# Access Compliance Report

## Public Rights-of-Way

### (Curb Ramps)

| Intersection ID: 49243 | Main Street: CONNESTEE_CT | Cross Street: TOXAWAY_LN | Location:              | E                  |

| ADA ID: 5B0BD8993C2A   | Ramp Type: PerpDiag       | Initial Pass/Fail: Fail  | Overall Compliance: No | Severity Score: 35 |

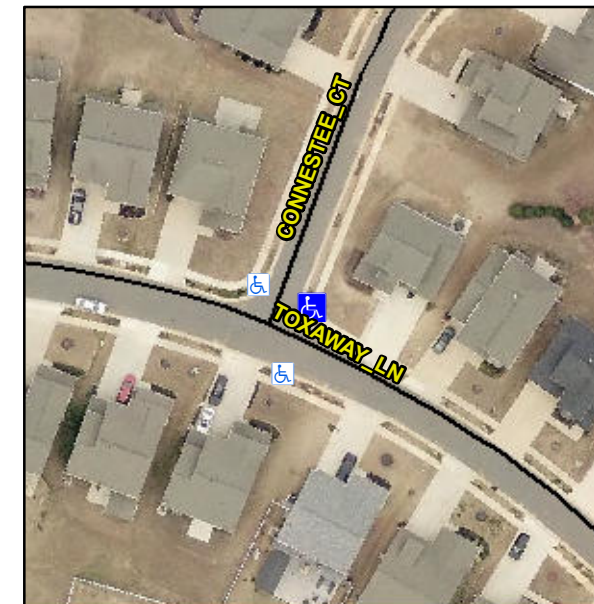
**Not Found, R304.5.1, R304.2.2, R304.5.3**

| Compliance | Description           | Data  | Compliance | Description                 | Data  |
|------------|-----------------------|-------|------------|-----------------------------|-------|
| N/A        | Ramp Length (in)      | 50.0  | No         | Ramp Slope (%)              | 16.5  |
| No         | Ramp Width (in)       | 44.5  | No         | Ramp XSlope (%)             | 3.1   |

**Remove & Replace Curb Ramp With Two New Directional Ramps or Equivalent.**
